Improvement 1

AIS FLARE SA15 SART

This document shows the difference between the measured versions at Phoenix Testlab and latest version of the device:

Measured Version	Latest Version
PCB 5400023A02; BOM V1.3	PCB 5400023A03; BOM V1.5
Case V1.0	Case V1.1

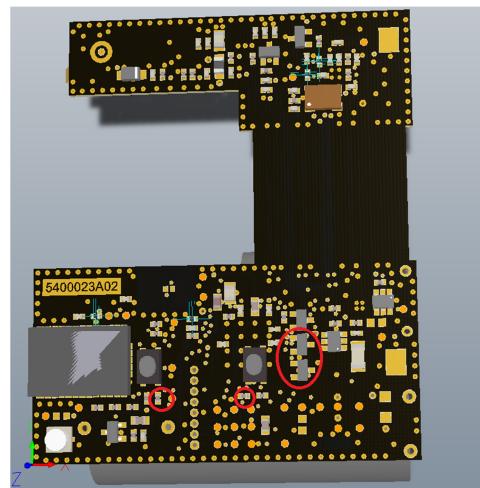
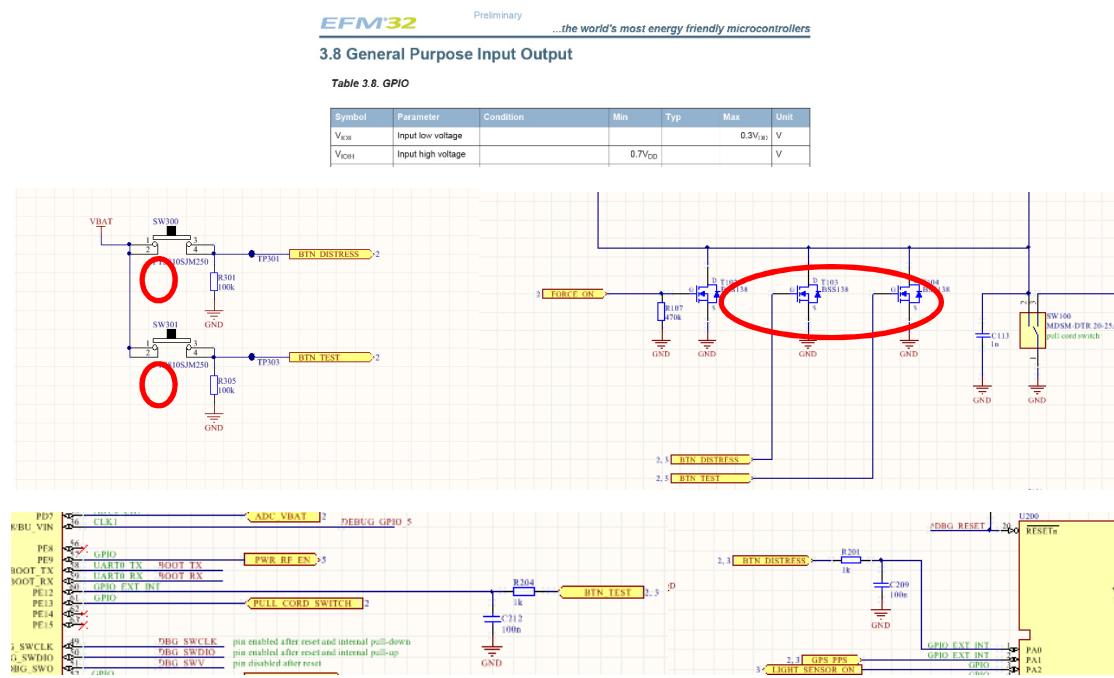
2.1 Switch off of the device below 2,31V

The microcontroller needs $3.3V * 0.7 = 2.31V$ at its GPIO input to read logic 1.

With the improvement it is now possible to switch off the device also if the battery voltage drops below 2,31V.

2.2 Additional REED-Switch

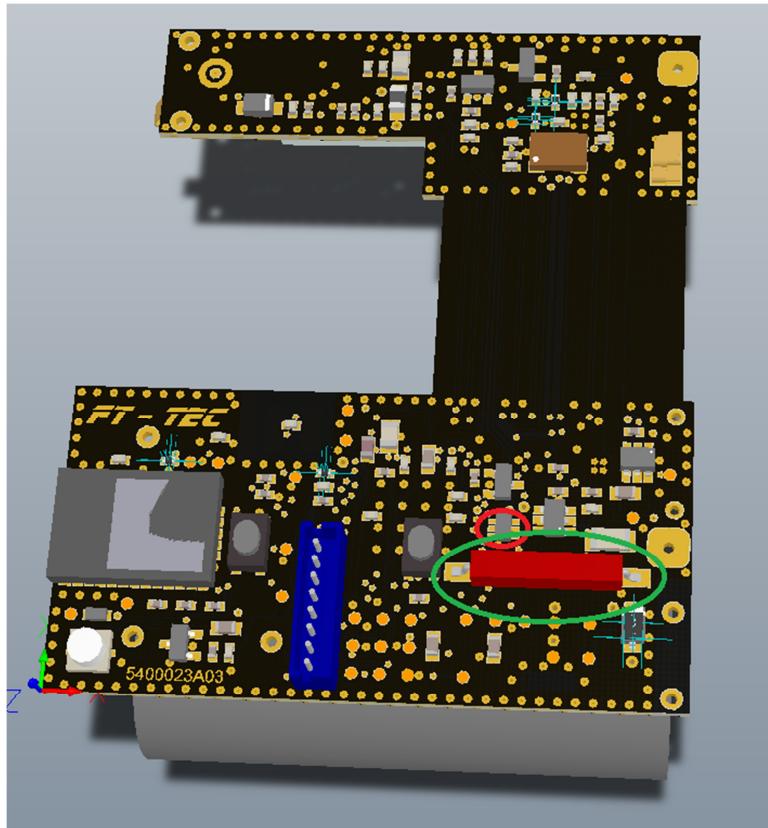
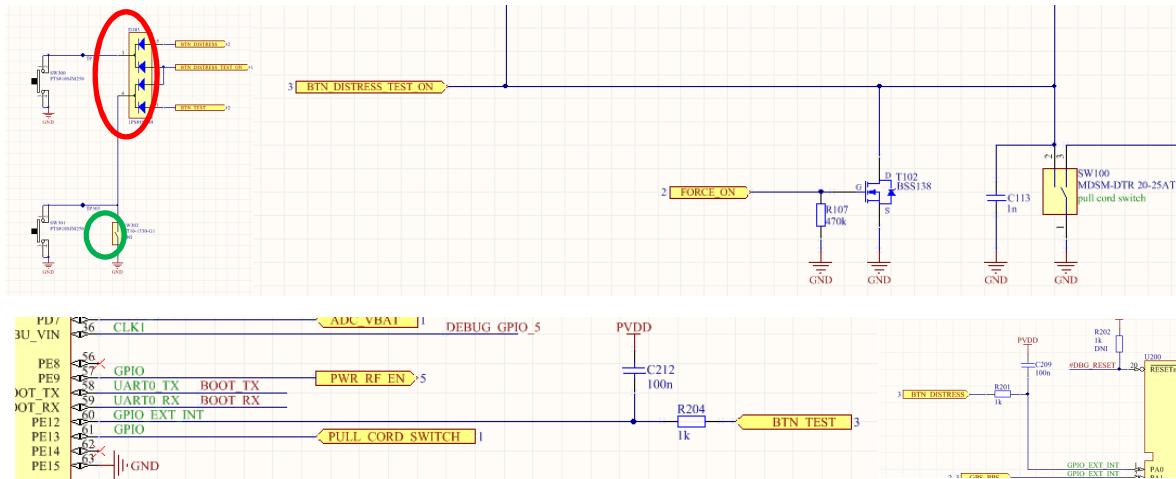
Additionally the PCB contains Pads to populate one reed switch (SW302) instead of the buttons (SW300 and SW301).

3 Increase PCB-Stability and improve PCB-Mounting into Case V1.1

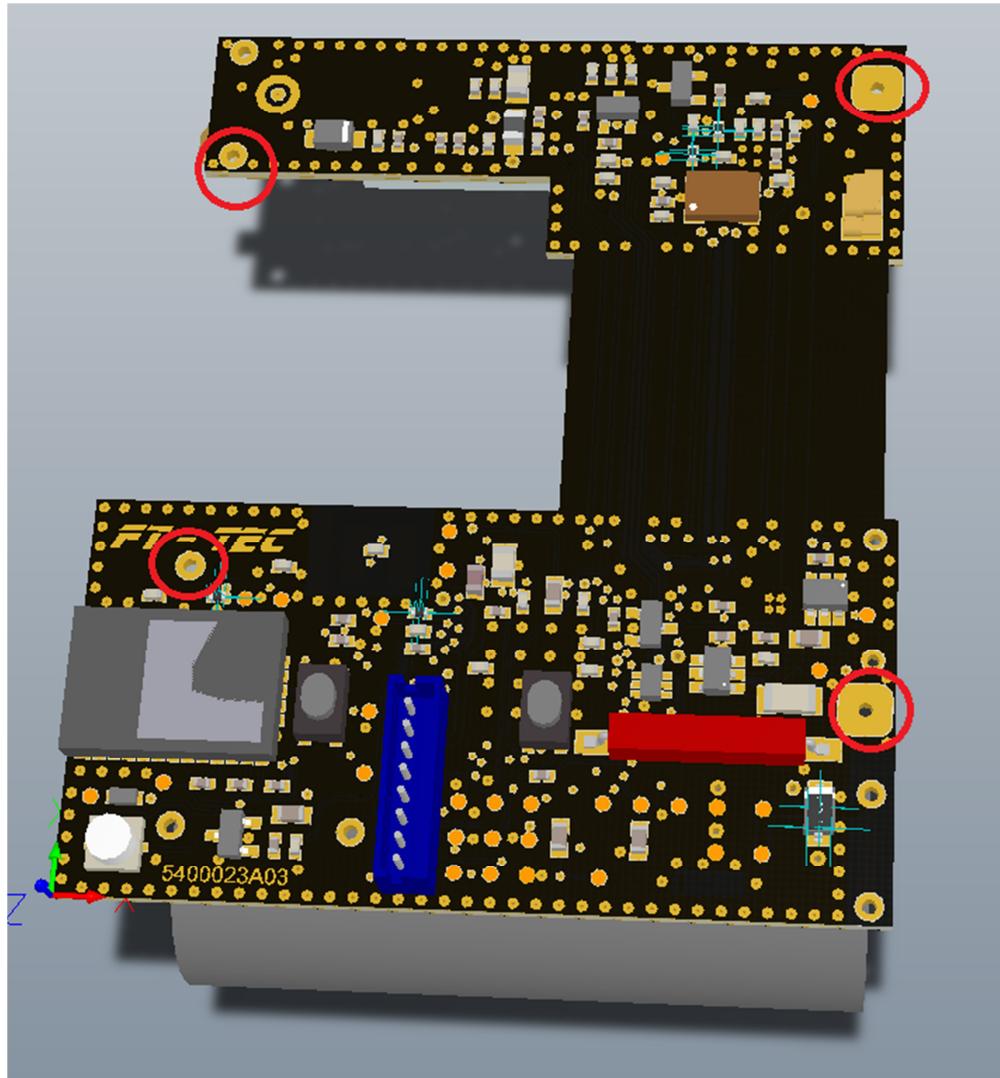
The PCB 5400023A03 and BOM V1.5 contain 4 extra THT pads to solder both PCB parts by board stackers together. That improves the stability of the PCBs and makes the mounting of the PCB to the case V1.1 much faster and easier. The inductor L100 was exchanged to a lower type.
